DART SERVICE INSTRUCTION

TO AMEND INSTALLATION INSTRUCTIONS IIN-D117-762 REV. E AND
INSTRUCTIONS FOR CONTINUED AIRWORTHINESS ICA-D117-762 REV. 4

The purpose of this Dart Service Instruction (DSI) is to replace the ground handling lugs (D3864-1 Bushings, AN6C51A Bolts and MS21043-6 Nuts) on the D117-762-XXX Skidtubes with a structurally superior lug design (D5300-1 Bushings, D5301-1 Plugs, AN6C52A Bolts, MS21043-6 Nuts) as shown in Figure 1. The new hardware will be included in D117-762-011 @ CHG 004 and subsequent.

A	NEW ISSUE	RF	17.01.09
REV.	DESCRIPTION	BY	DATE
DESIGN	RF	DART AEROSPACE, LTD EUGENE, OR	
DRAWN	RF		
CHECKED	WK	DRAWING NO.	REV.A
MFG. APPR.	N/A	DSI 9771	SHEET 1 OF 2
APPROVED	HS	TITLE	SCALE
DE APPR.		GHL UPGRADE KIT	NTS
DATE	17.01.09	COPYRIGHT ©2017 BY DART AEROSPACE USA, INC THIS DOCUMENT IS PRIVATE AND CONFIDENTIAL AND IS SUPPLIED ON THE EXPRESS CONDITION THAT IT IS NOT TO BE USED FOR ANY PURPOSE OR COPIED OR COMMUNICATED TO ANY OTHER PERSON WITHOUT WRITTEN PERMISSION FROM DART AEROSPACE, LTD.

FIGURE 1 - GHL UPGRADE INSTALLATION

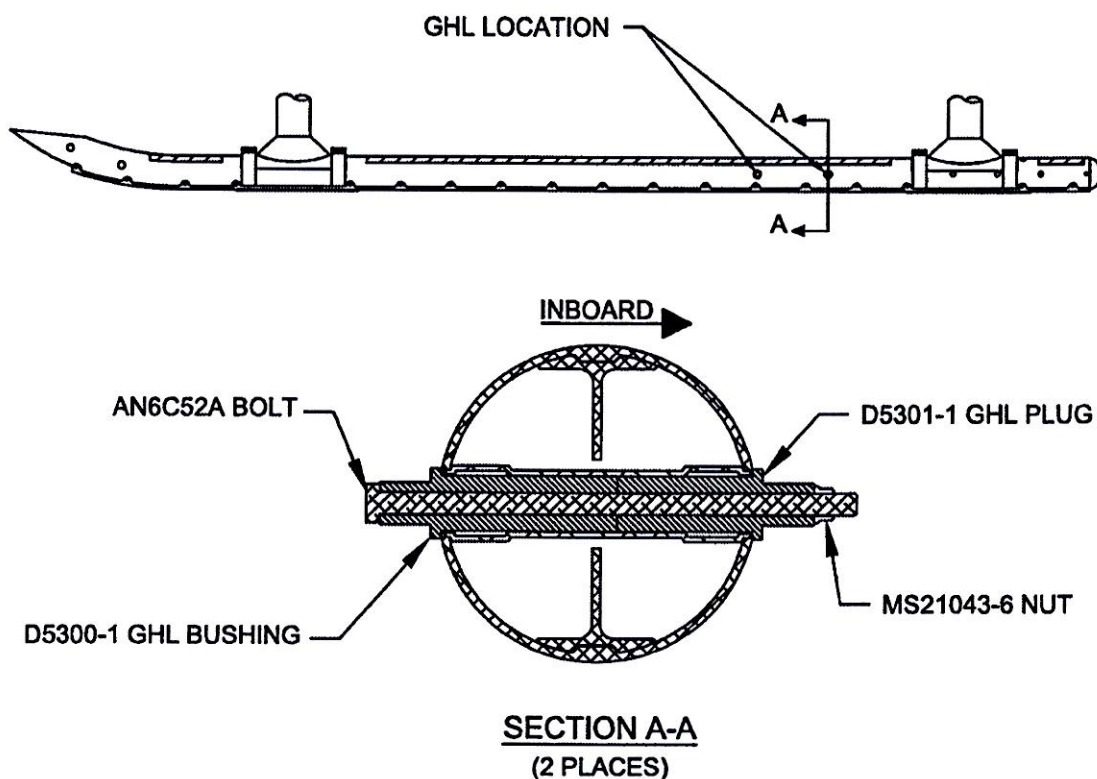
- 2.1 Loosely install (qty 2) D5300-1 GHL Bushing & (qty 2) D5301-1 GHL Plug wet with Proseal 890 or MIL-S-8802 Class B2 Sealant in location shown in Figure 1.
- 2.2 Install (qty 2) AN6C52A Bolts and (qty 2) MS21043-6 Nuts in accordance with Figure 1. Clean up squeezed out Proseal and apply fillet seal around D5300-1 & D5301-1.
- 2.3 Torque AN6C52A Bolts 160 - 190 in-lbs (18.1 - 21.5 N-m).

ITEM	QTY -011	PART NUMBER	DESCRIPTION
	X	D117-762-011	SKIDTUBE INSTALLATION
50	2	AN6C52A	BOLT
51A	2	D5300-1	GHL BUSHING
51B	2	D5301-1	GHL PLUG
52	2	MS21043-6	NUT

ITEM	QTY -011	PART NUMBER	DESCRIPTION
	X	D117-762-011	SKIDTUBE INSTALLATION
50	2	AN6C51A	BOLT
51	4	D3864-1	BUSHING
52	2	MS21043-6	NUT
